Philips Lighting Comments on the Proposed Revisions to the California Building Energy Efficiency Standards California Code of Regulations, Title 24, Part 6 and Appendices; 145-Day Language

Comments for Proposed Language for 2016 Title 24 Part 06 & 2016 Joint Appendices

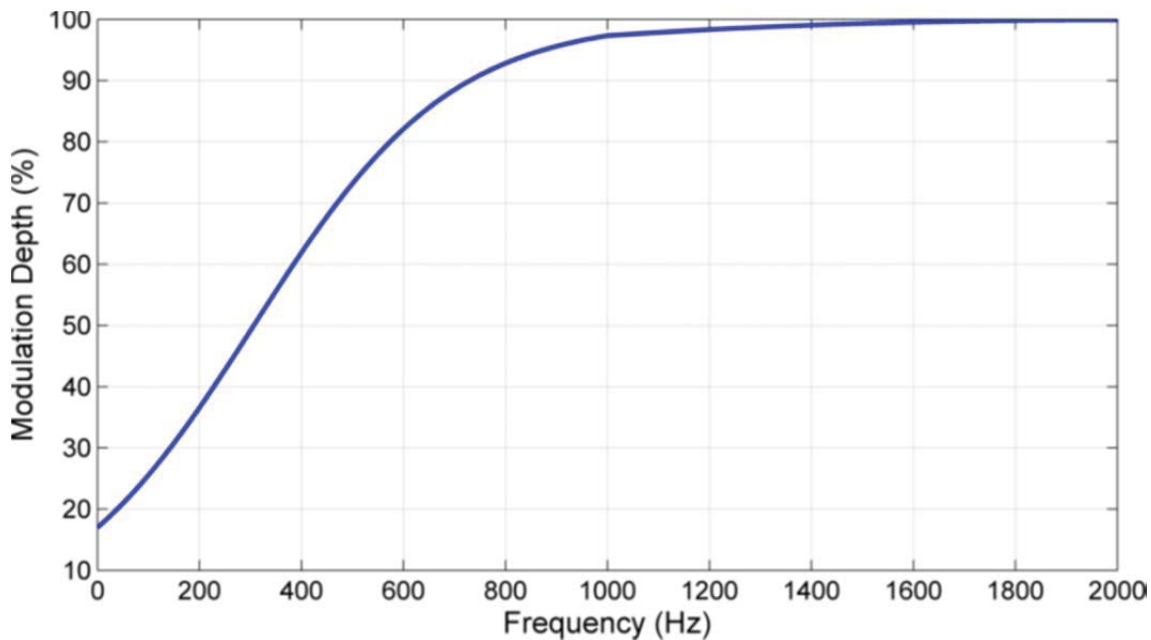
JA-8’s restrictions on flicker, as summarized in Table JA8, are overly restrictive for some frequencies and too lax for others. The human eye definitely does not have a flat response over the range from 0 to 200 Hz.

This specification makes no allowance for the dependence of human flicker sensitivity either on frequency or on wave shape. For sine wave modulation, the visibility threshold for stroboscopic

effects¹, expressed in terms of modulation depth, is shown in the figure below. At a particular frequency, modulation depths above the curve can be detected by most people. Below the curve, they are not detected by most people. The threshold changes for different wave shapes, in a way that depends on the Fourier components of the light output waveform. A full Fourier approach would take into account both frequency and wave shape effects.² Sensitivity to flicker also depends on the application. Flicker perceived in outdoor street lighting or in stairwells is better tolerated by occupants than flicker perceived in indoor office lighting, for instance. Therefore, a curve of acceptability may be above the visibility threshold curve. Different curves may be needed for different applications.

Zooming in on the region from 0 to 200 Hz in the figure above, the shaded rectangular region with dashed outline represents the conditions allowed by the Title 20 specification. The red triangle is forbidden by the Title 20 specification, but flicker in this region is not visible to most observers. Title 20, as a MINIMUM specification, should not exclude acceptable regions where flicker is not even be detected.

- **We continue to oppose the over-specified performance parameters as defined in JA8, and strongly urge that any specifications on flicker and test procedures should wait until experts in this field (IEEE, NEMA and in IEC) conclude their work on this topic and produce a solid standard. It should be noted that ENERGY STAR is also collecting data on flicker and should complete their work and make recommendations to allow California to harmonize with the Energy Star specification.**
- **If the CEC is unwilling to remove the flicker specification and wait for alignment in standards organizations, then CEC should at the very least modify the present specification to allow use of the acceptable flicker region denoted by the red triangle in the figure above. We suggest modifying the specification to allow flicker in the region shown in the figure below:**

The specification would then be: “Dimmer controls that can directly control lamps shall provide electrical outputs to lamps for reduced flicker operation through the dimming range so that the light output has an amplitude modulation below the line, Modulation Depth = 20% + Frequency/10, for frequencies from 100 to 200 Hz, without causing premature lamp failure.”
